CITY OF DULUTH

File Number	PL 18-122	Contact	Jenn Reed Moses	
Type	MU-W Planning Review	Planning Commission Date	November 13, 2018	
Deadline for Action	Application Date	September 20, 2018	60 Days	November 19, 2018
	Date Extension Letter Mailed	October 1, 2018	120 Days	January 18, 2019
Location of Subject	1033 Minnesota Avenue			
Applicant	Park Point Marina Inn and Suites LLC	Contact	Terry Anderson	
Agent	N/A	Contact	N/A	
Legal Description	010-4390-02090, 010-4400-00780			
Site Visit Date	October 2, 2018	Sign Notice Date	September 25, 2018	
Neighbor Letter Date	October 1, 2018	Number of Letters Sent	23

Proposal

The applicant is proposing a 3 story, 6,100 square foot, 15 room addition to the southeast side of the existing hotel. Staff has revised the report and proposed conditions since the October 9, 2018 Planning Commission meeting where the Applicant's request was tabled.

1 SITE CONCEPT PLAN

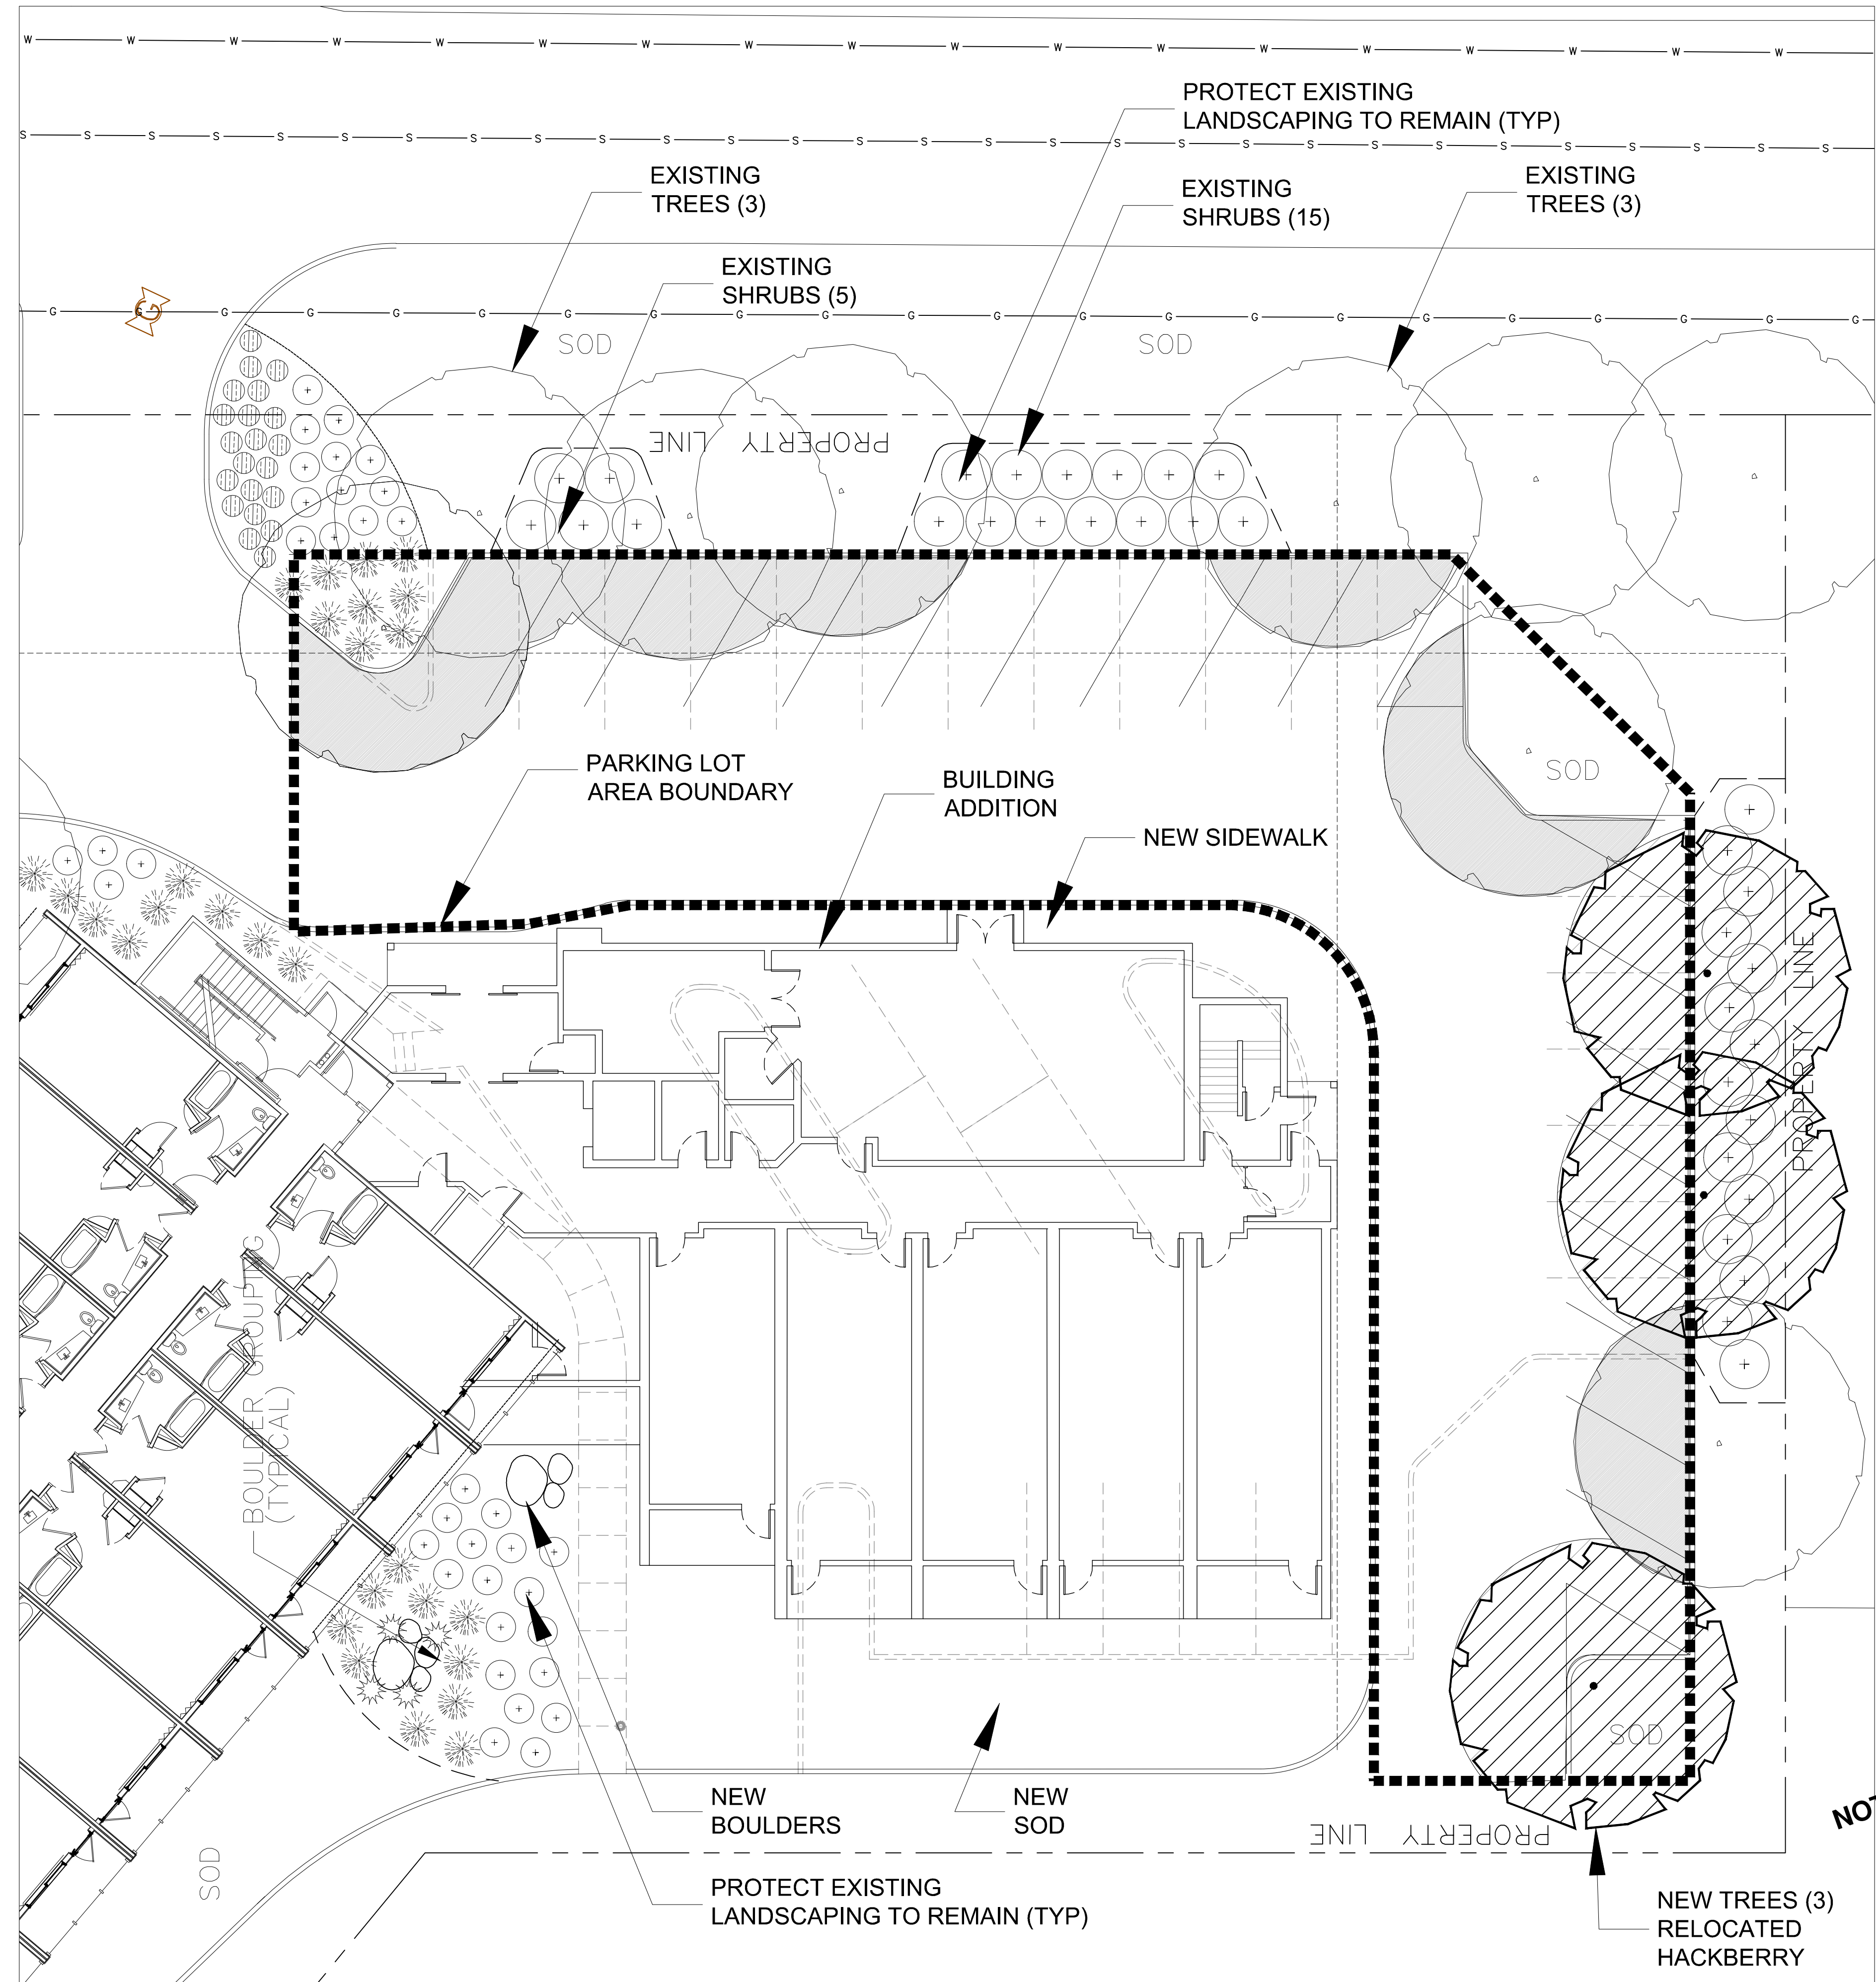
- 4) 50-18.1 (Natural Resources Overlay District) - Site is within a floodplain and will need to meet elevation requirements. Structure meets the 50 foot shoreland setback requirements. The proposed plan eliminates

some stormwater control features (landscape island SE corner of the site). According to City Engineering, this infiltration basin will need to be replaced somewhere else on the site, with plans for its replacement completed prior to issuance of a building permit.

- 6) 50-24 (Parking) - Off-street parking requirements for hotels are based on the number of rooms and accessory areas. 87 parking spaces are required. The applicant is proposing 74 off-street parking spaces. The 30% reduction is not applicable here because of the site's location related to adjacent R-1 properties. This site was previously developed with the 30% reduction for transit proximity; however, the proposed 15-room addition is located on previously required parking areas. The addition of hotel rooms will increase parking demand. Additional staff evaluation of transit use by hotel customers or employees indicates that such use is negligible based on the lack of regular, reliable transit service in this location. The application fails to demonstrate that nearby properties provide supplemental on-street or off-street parking. The site plan indicates that the hotel will rely on the adjacent marina's drive aisle for parking access, and that an easement for this use has been recorded.

4. Prior to issuance of a building permit, Applicant shall provide an additional 13 parking spaces on or immediately adjacent to the site, or demonstrate that supplemental parking is available within 500 feet of the site with off-street pedestrian access using a trail or sidewalk connecting to the hotel's primary entrance.

PROPOSED ADDITION - HARBOR ELEVATION

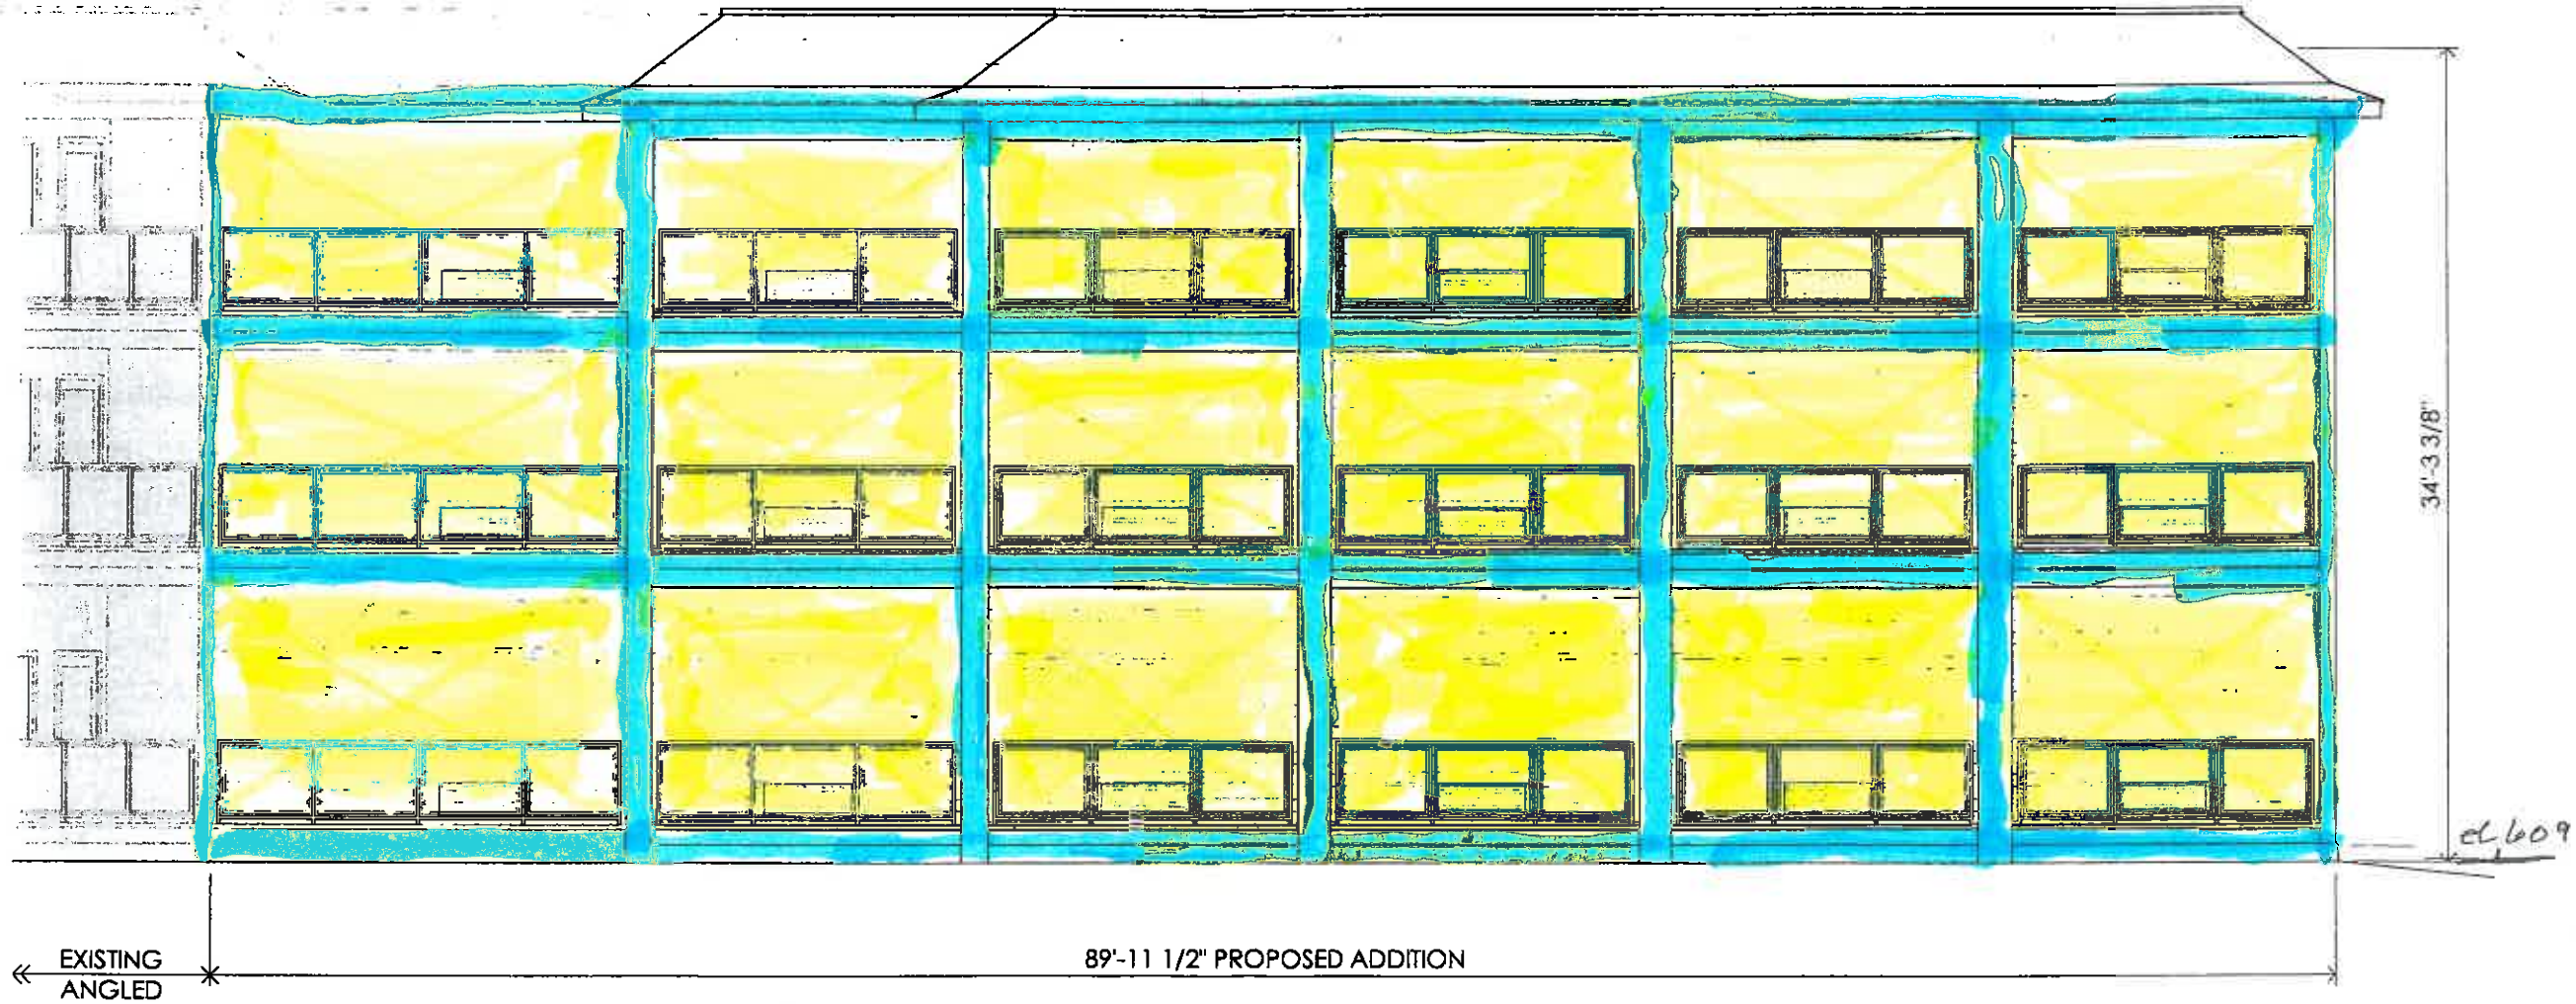
- 3) 50-15.6.E (Development Standards) – #2 The proposed expansion will meet the required minimum 50 foot setback from adjacent structures. #4 Applicant states the project will meet the minimum 40% transparency requirement along the waterfront. #5 The proposed expansion will add rooms and take away existing off-street parking spaces; see item 5 below.

3. Prior to issuance of a building permit, Applicant shall submit professionally drawn elevations signed by a Licensed Architect that include measurements demonstrating that the façade facing the water meets the 40% transparency requirement of the UDC.
